P&Z CASE # Z2018-016 **P&Z DATE**_____ **CC DATE**_____ **APPROVED/DENIED**

Case Number: Z2018-016
Case Name: Zoning Change (C to PD)
Case Type: Zoning
Zoning: Commercial (C) District
Case Address: NWC of Ridge Road and Turtle Cove Blvd.

PLANNING COMMENTS - DAVID GONZALES - 03.21.2018

AGENDA ITEM: **Z2018-016**; Zoning Change (C *to PD) for Waterview Ridge*

CONCEPT PLAN

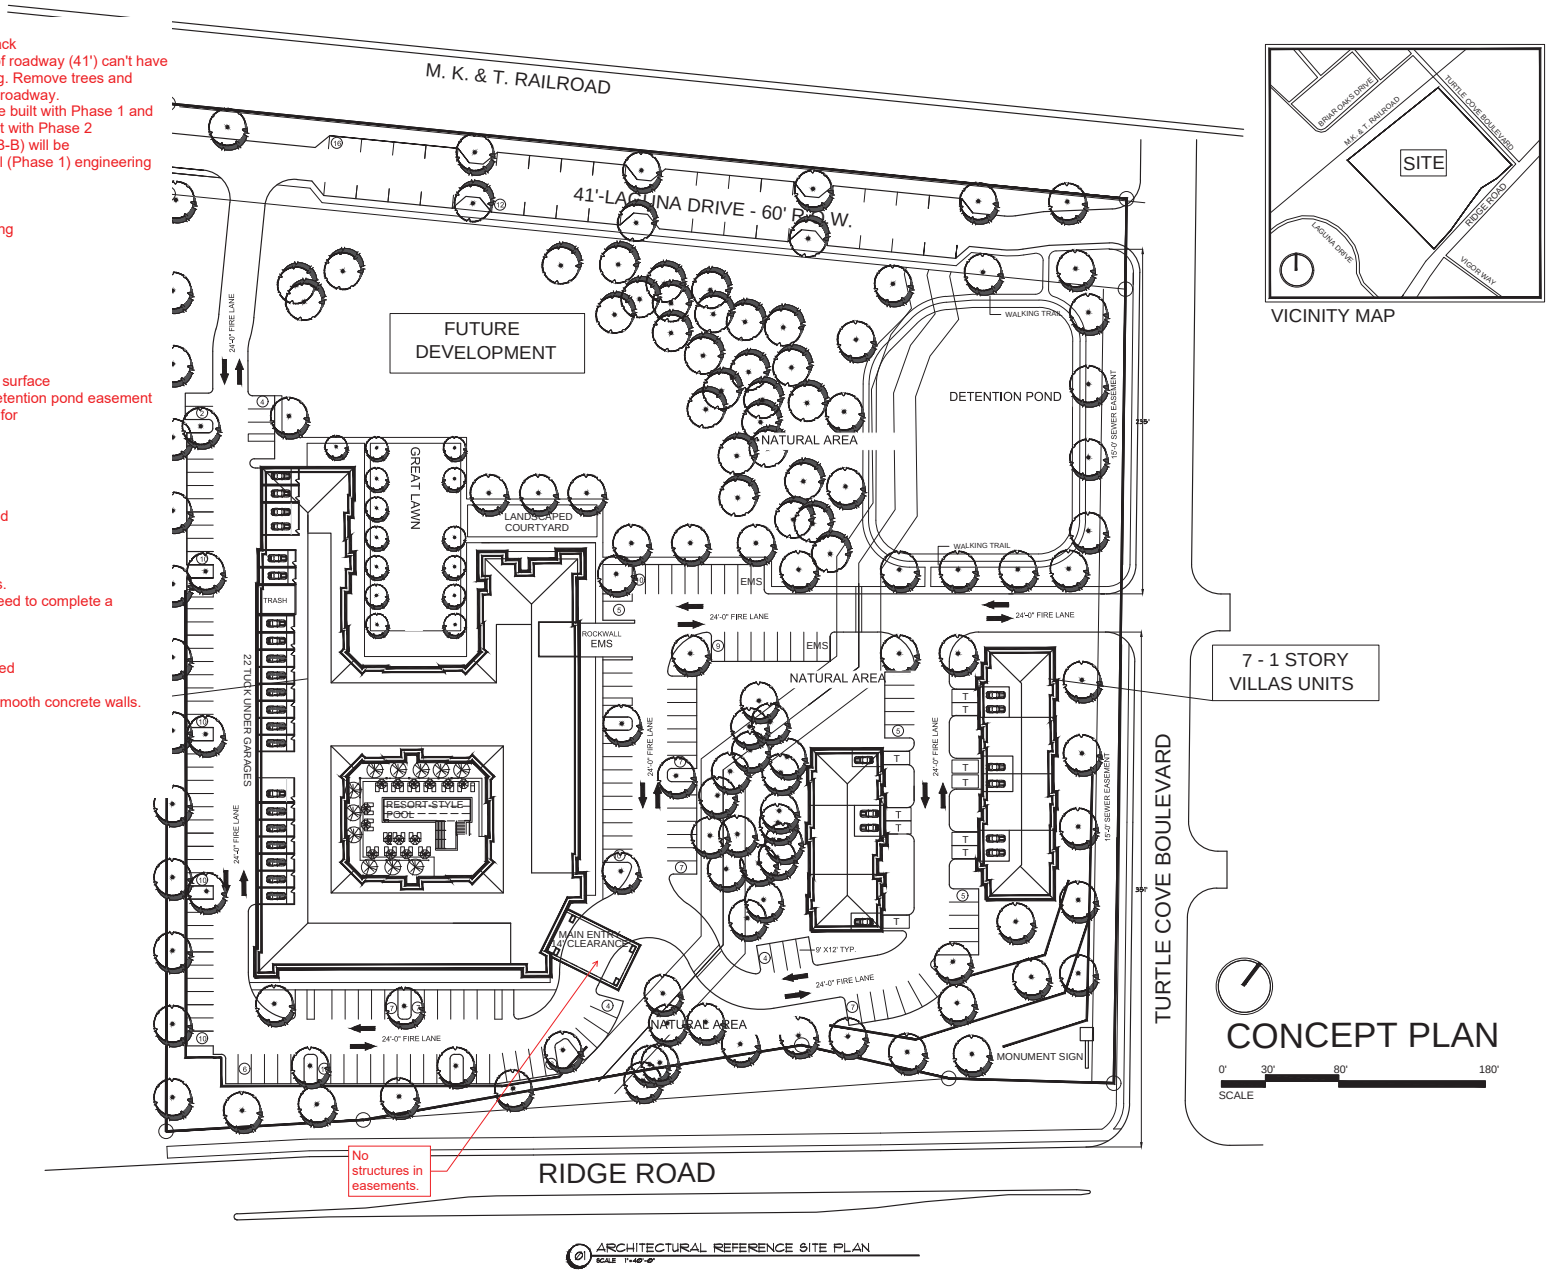
Please make the following corrections/additions to the Concept Plan:

(1) Provide % of open space and label for each separate area on the concept plan (i.e. detention areas, landscape buffers, park area, etc.).

(2) Parking Required - Section 6.5, of Art. VI, of the UDC:Section - Requires a reommendation from the Planning and Zoning Commission and approval of the City Coucil for the following:
a) Reduction in amount of parking spaces provided per bedroom units:
i. One bedroom/efficiency requries 1.5 parking spaces for each 1-bedroom unit within the complex.
ii. Two bedroom requries two (2) parking spaces for each 2-bedroom unit within the complex.
iii. Townhouse requires two (2) parking spaces for each dwelling unit.
b) Provide calculations for EMS interior/living area facilities and remainder of all other land area's associated with EMS use in order to calculate parking requirements [EMS parking = 1:300 SF building & 1:750 SF of site area].

(3) Proposed Laguna Drive - is a Minor Collector and requries a minimum 60-ft right-of-way with a 41-ft back to back layout.
a) Niche parking not permitted as indicated (i.e. striped, bottle neck design).
b) Remove tree wells from within the ROW as depicted.
c) Remove striping as indicated.
d) Remove parking space count labels -- does not counttowards parking calculation.

(4) Verify and correct scale as represented. Does not scale to 1 inch = 30-ft.

(6) Provide calculation of density -- dwelling units per acre.

(7) Provide a legend with the following information:
a) Total Gross Acres
b) Dwelling Units per Acre
c) Open Space Acres
d) Total Floodplain Acres
e) Number of Dwelling Units (i.e. 1 bedroom/2 bedroom)

- Need to show a phasing plan
- Laguna Drive to be 41' back to back of curb, 60' ROW. The full width of roadway (41') can't have tree wells or striped parallel parking. Remove trees and striping out of the 41' back to back roadway.

- Minimum of 24' of Laguna shall be built with Phase 1 and the remainder of the 41' will be built with Phase 2
- The fully developed Laguna (41' B-B) will be designed/engineered with the initial (Phase 1) engineering plans including drainage.

- Must loop water line on site.
- Walls 3' and over must be designed by a licensed engineer.
- All walls to be rock or stone. No smooth concrete walls.
- Must meet all City Engineering Standards.

01 CONCEPT- EXTERIOR ELEVATION
SCALE NTS

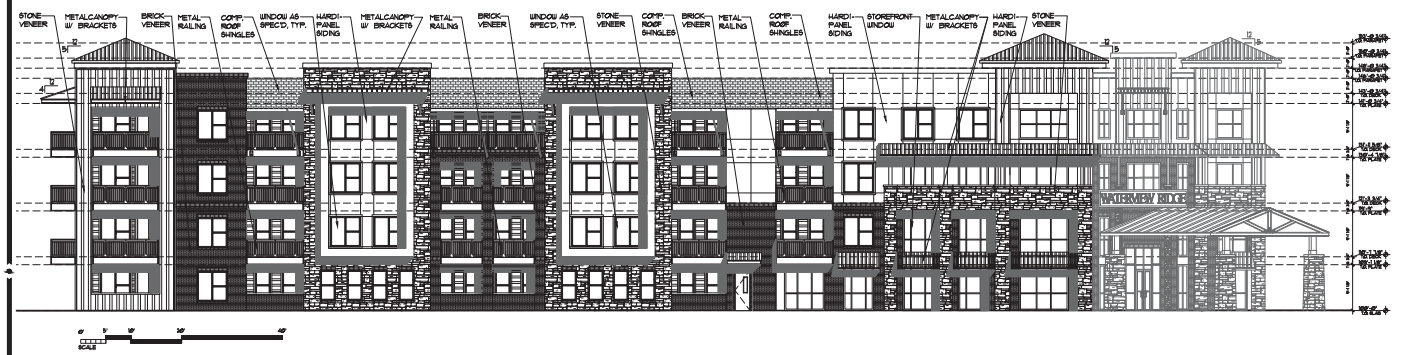
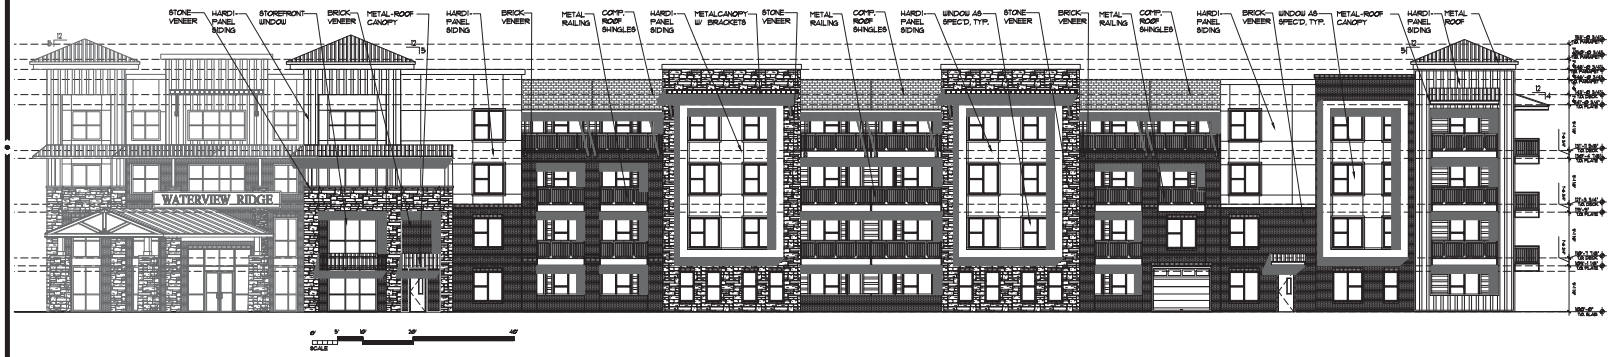
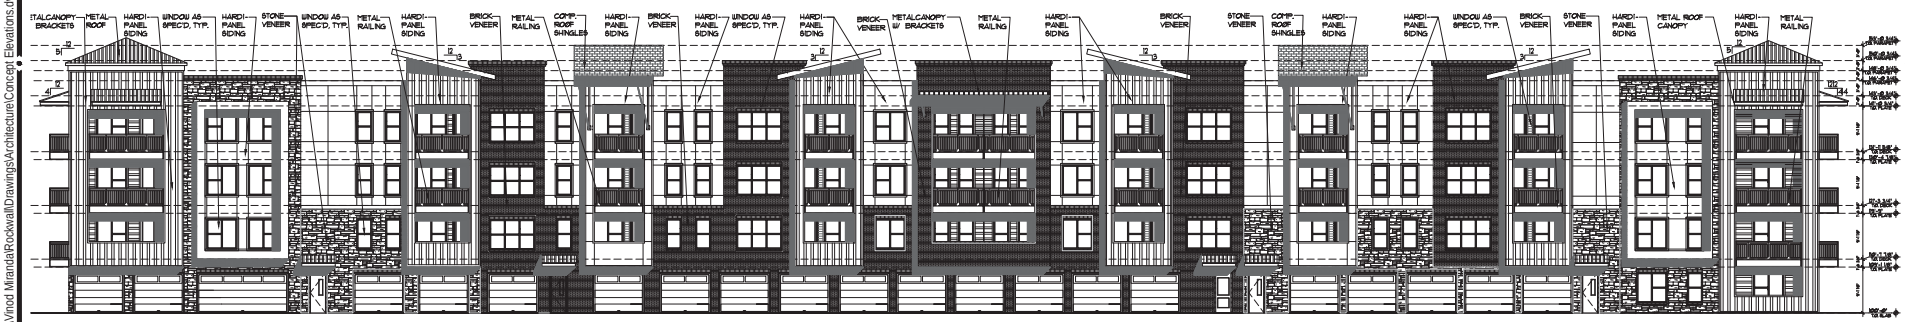
• Proposed building elevations are to meet the City's minimum standards as provided for within the Scenic Overlay (SOV) District:
a) please provide exterior materials calculations (i.e. stone % for each elevation, masonry %, fiber board %, etc.)
b) structures exceeding 36-ft in height within the SOV require approval (see Special Use Standards).
